RE: Yiribana Logistic Estate West – Transport Assessment Addendum

I refer to our recent correspondence in relation to the Yiribana Logistics Estate West (Yiribana West), located at 771-797 Mamre Road, Kemps Creek (the Site). It is understood that, since submission of the Development Application (DA) to Penrith City Council (Council), modifications have been made to the Sydney Water infrastructure corridor which has resulted in subsequent changes to the proposed development yields.

Therefore, this Transport Assessment (TA) Addendum has been prepared as update to the following report:

Figure 2: Proposed Revised Masterplan

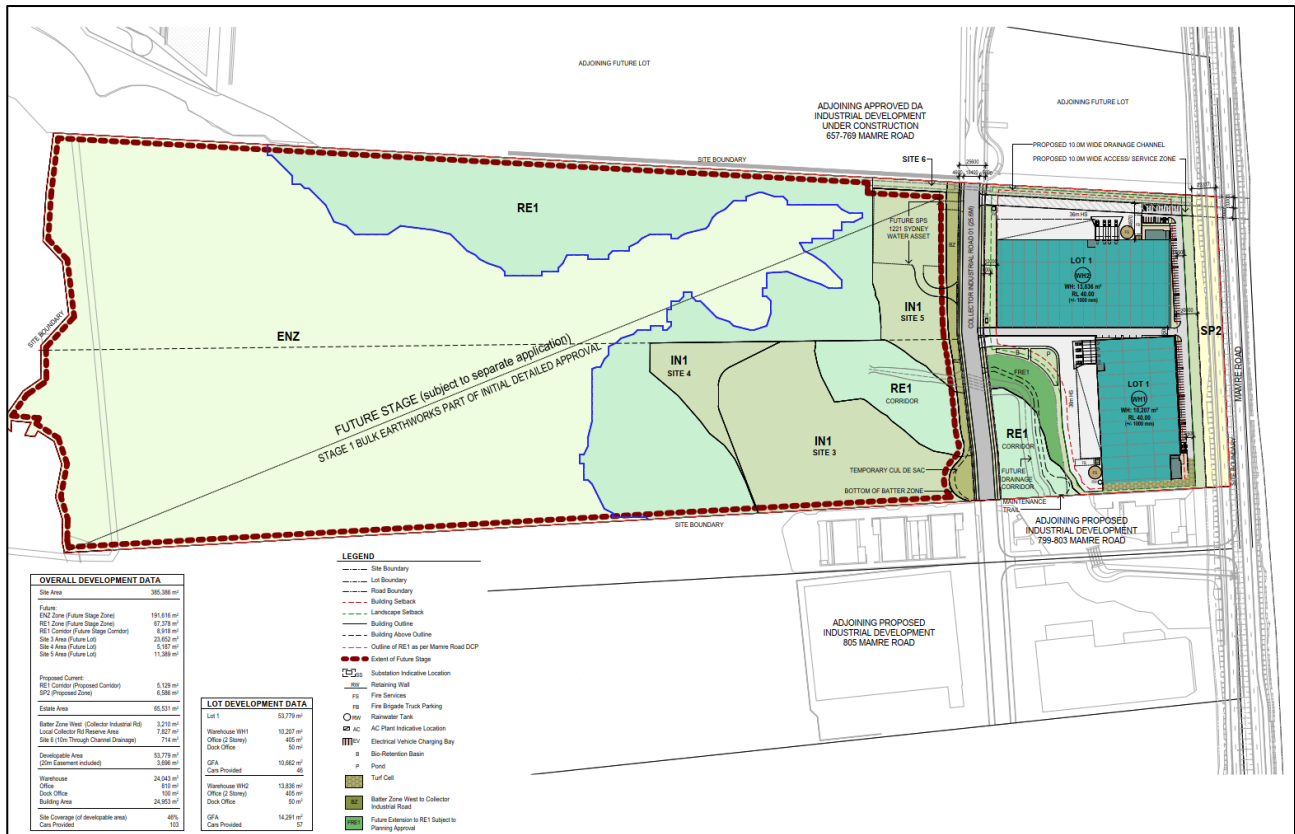
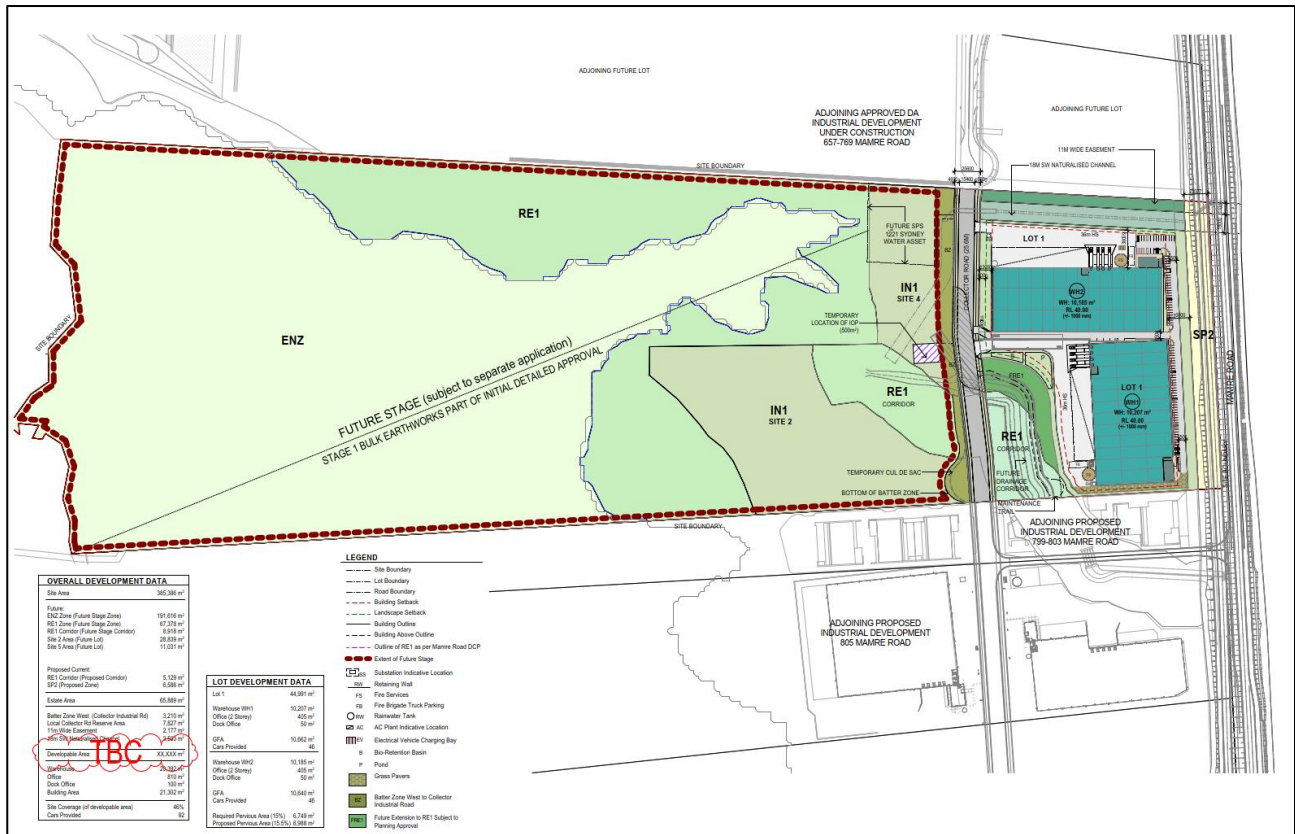
The key changes relate to Proposal include the reduction of Warehouse 1B (now referred to as Warehouse 2) GFA due the increased corridor width and design of the Sydney Water easement and naturalised channel, located north of the Warehouse.

- Warehouse 1: 10,207m² warehouse GFA and 455m² office GFA;
- Warehouse 2: 10,185m² warehouse GFA and 455m² office GFA; and
- Provision of the north-south industrial collector road.

Critically, the updated Masterplan includes a reduction in the total GFA. Therefore, the impacts of the Site on the transport network would be reduced than that previously assessed by the Ason TA.

SHEET
AG01

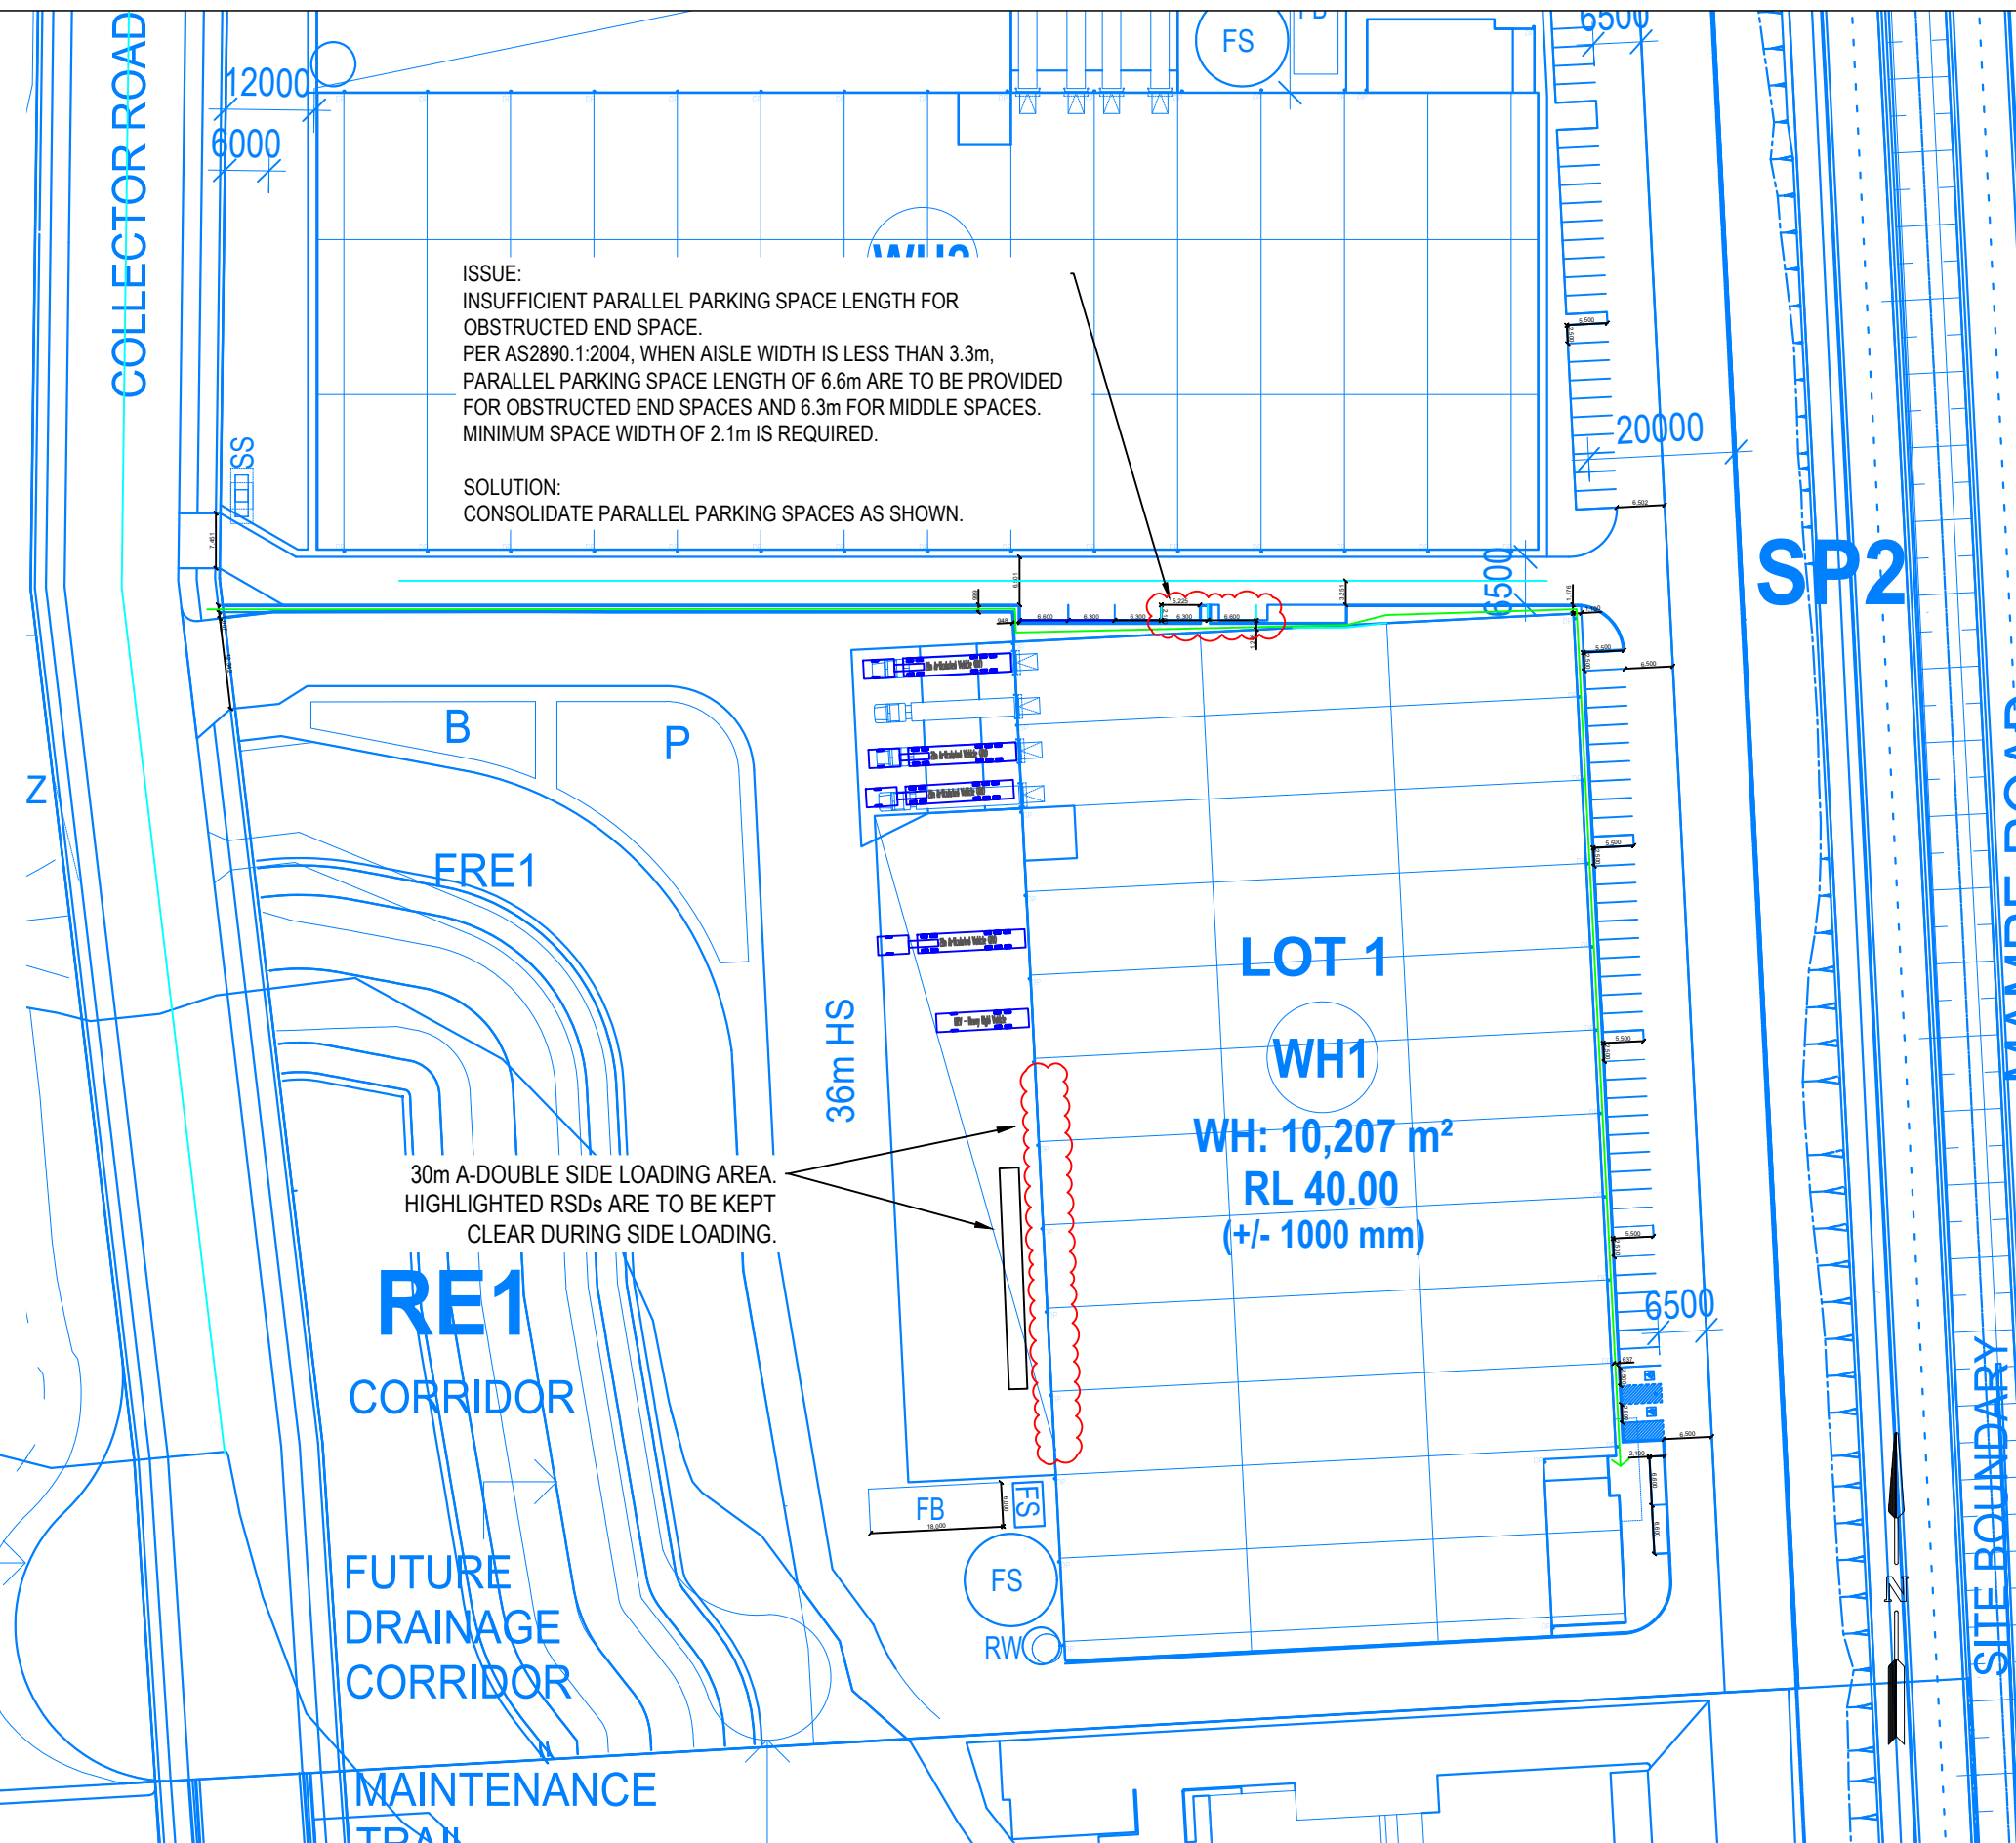
1. CAR PARKING PROVISION:
 - 1.1 WAREHOUSE 1: MRP DCP 2021 REQUIRES THE PROVISION OF 45 CAR PARKING SPACES (INCLUDING 1 ACCESSIBLE PARKING SPACE) FOR THE SITE.
2. USER CLASS 1 PARKING IS REQUIRED AS PER AS2890.1:2004. PARKING SPACE FOR USER CLASS 2 (WIDTH 2.5m) HAS BEEN PROVIDED WHICH COMPLIES WITH AS2890.1:2004.
3. SITE CIRCULATION FOR HEAVY VEHICLE IS ASSUMED TO OCCUR ONE-WAY IN A CLOCKWISE DIRECTION.
4. DESIGN VEHICLES ADOPTED:
 - 4.1 30.0m A-DOUBLES: SITE ACCESS AND CIRCULATION
 - 4.2 20.0m ARTICULATED VEHICLES (AVs): COMMERCIAL VEHICLE HARDSTAND AREA REVERSE LOADING (FOR 4 RECESSED DOCKS AND ALL RSDs OF THE WAREHOUSE).
 - 4.3 HRV: FOR FIRE CIRCULATION.
5. DRIVEWAY GRADE WAS NOT PROVIDED AND IS TO BE ASSESSED WITH UPDATED SITE PLAN.
6. ACCESSIBILITY CONSULTANT TO REVIEW AND CONFIRM FOOTPATH WIDTH AND ARRANGEMENT.

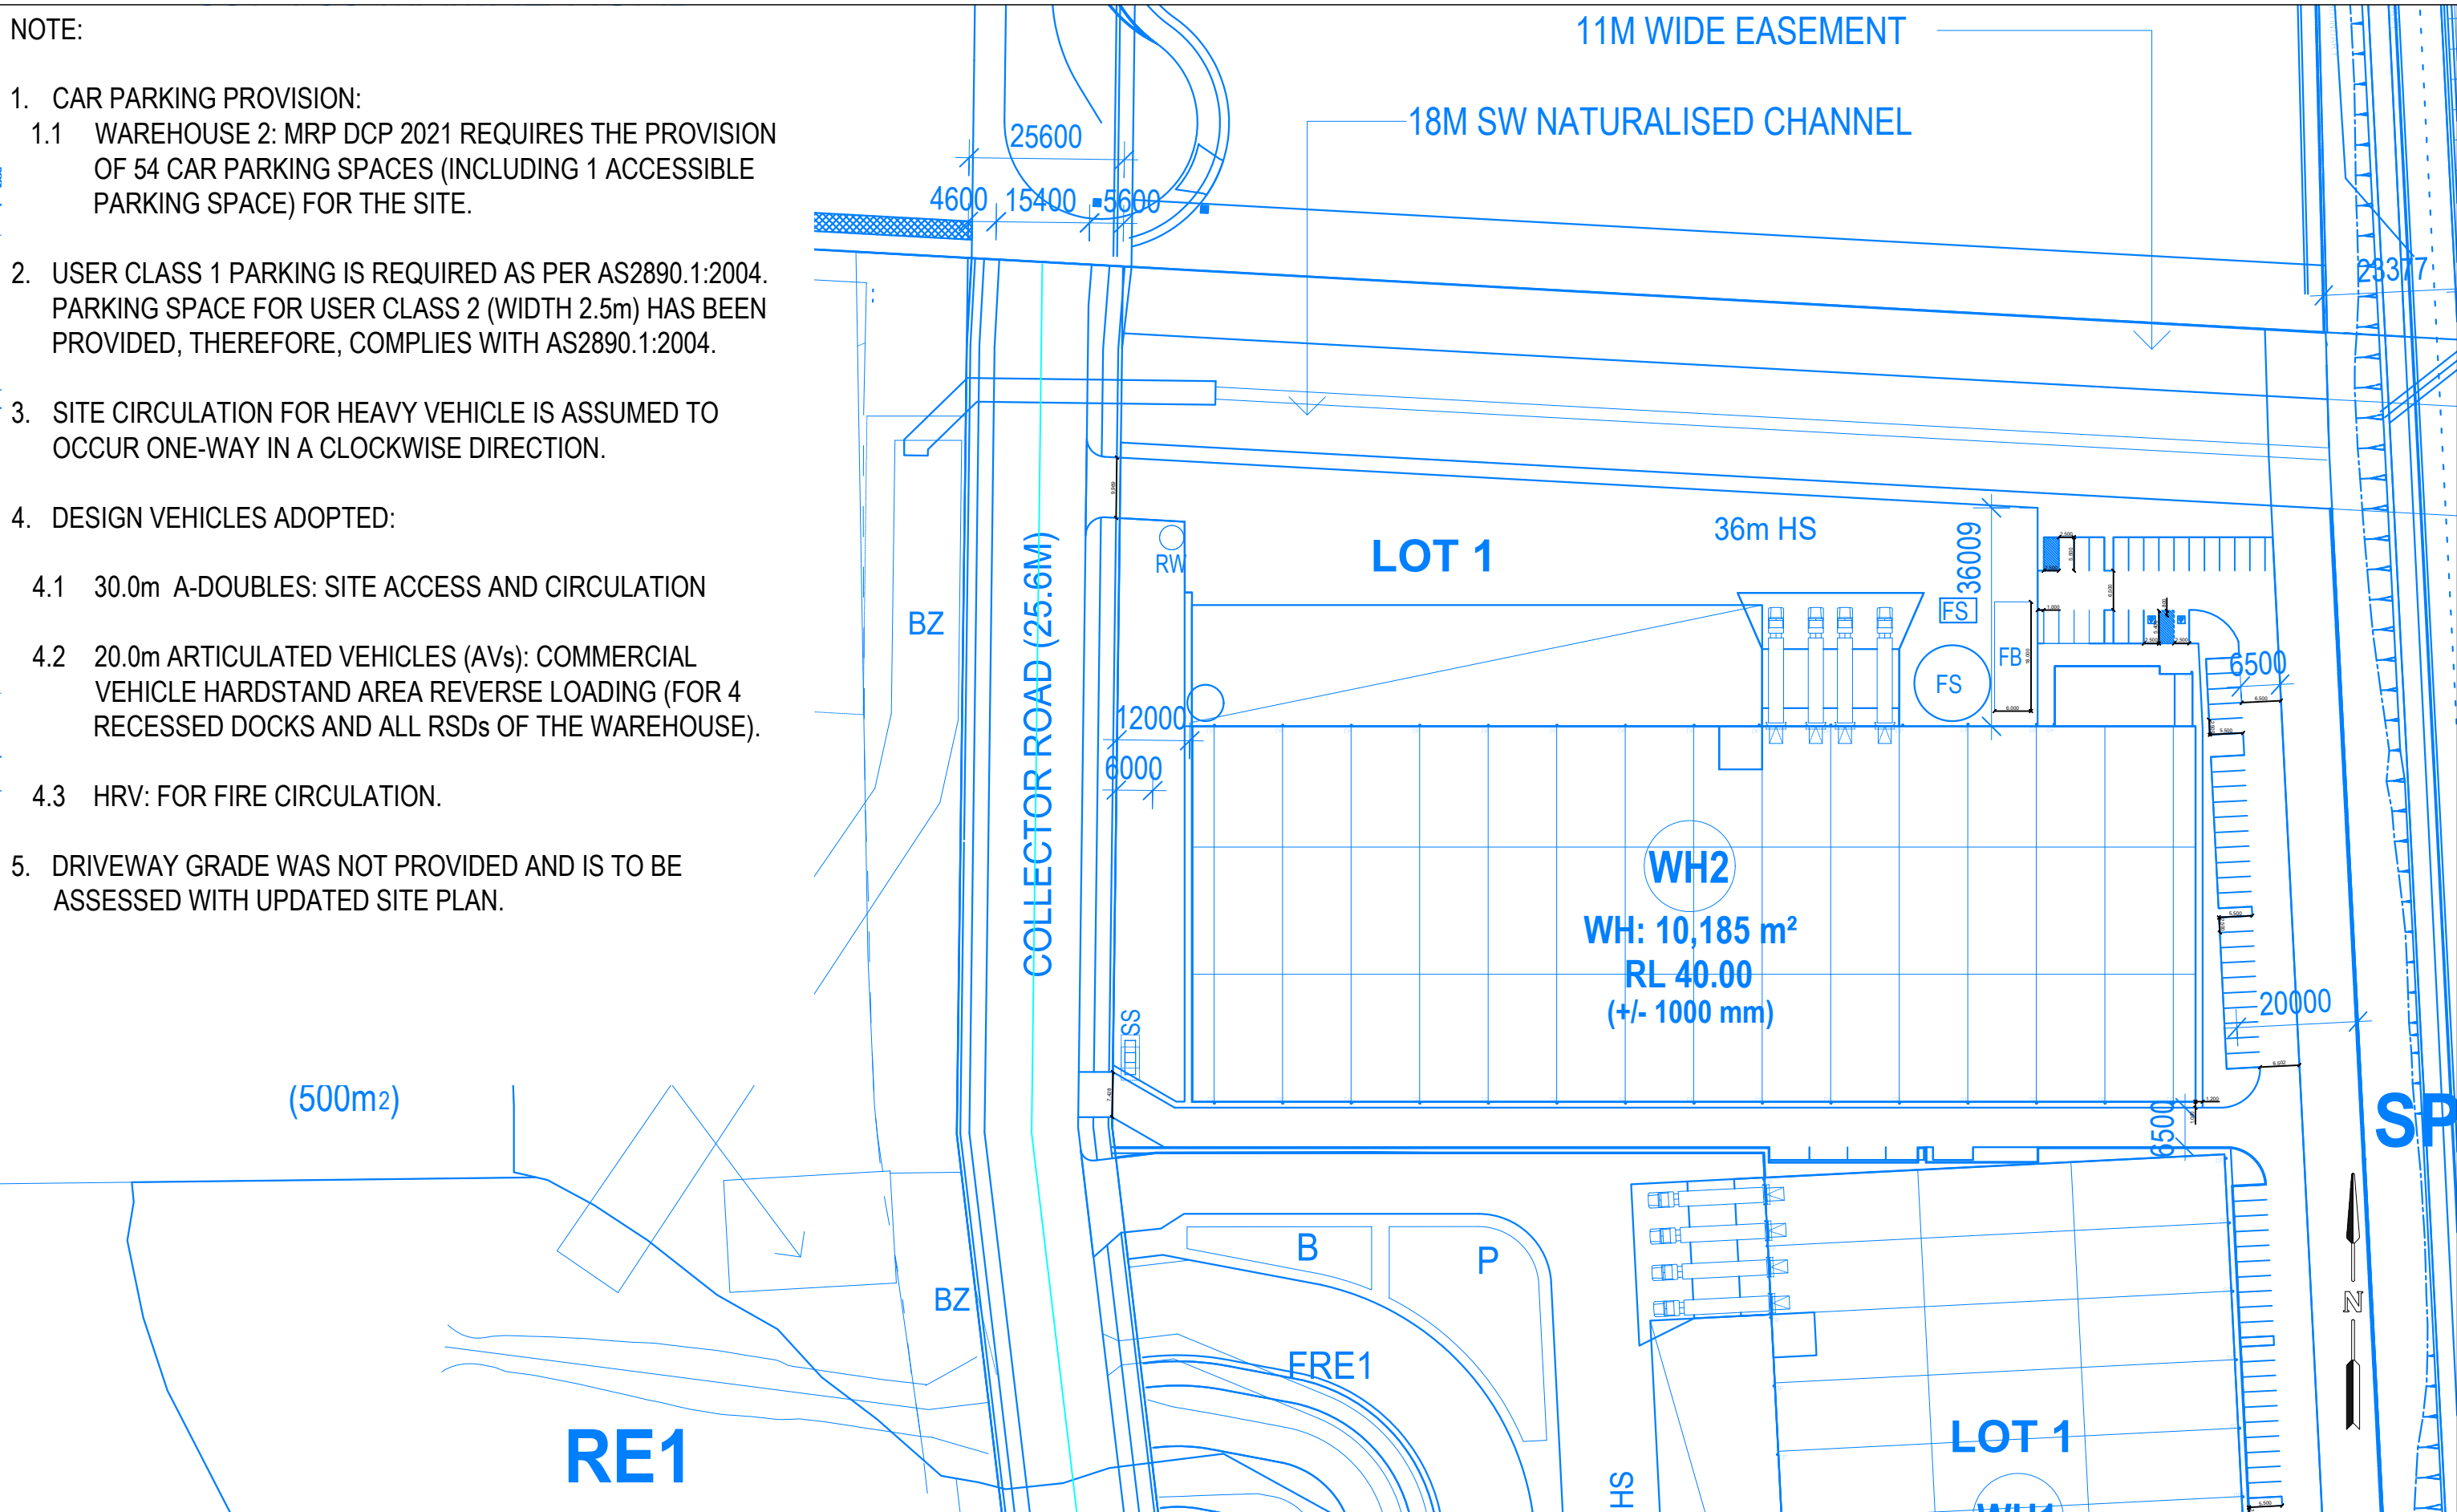
- CAR PARKING PROVISION:
 - WAREHOUSE 2: MRP DCP 2021 REQUIRES THE PROVISION OF 54 CAR PARKING SPACES (INCLUDING 1 ACCESSIBLE PARKING SPACE) FOR THE SITE.
- USER CLASS 1 PARKING IS REQUIRED AS PER AS2890.1:2004. PARKING SPACE FOR USER CLASS 2 (WIDTH 2.5m) HAS BEEN PROVIDED, THEREFORE, COMPLIES WITH AS2890.1:2004.
- SITE CIRCULATION FOR HEAVY VEHICLE IS ASSUMED TO OCCUR ONE-WAY IN A CLOCKWISE DIRECTION.
- DESIGN VEHICLES ADOPTED:
 - 30.0m A-DOUBLES: SITE ACCESS AND CIRCULATION
 - 20.0m ARTICULATED VEHICLES (AVs): COMMERCIAL VEHICLE HARDSTAND AREA REVERSE LOADING (FOR 4 RECESSED DOCKS AND ALL RSDs OF THE WAREHOUSE).
 - HRV: FOR FIRE CIRCULATION.
- DRIVEWAY GRADE WAS NOT PROVIDED AND IS TO BE ASSESSED WITH UPDATED SITE PLAN.
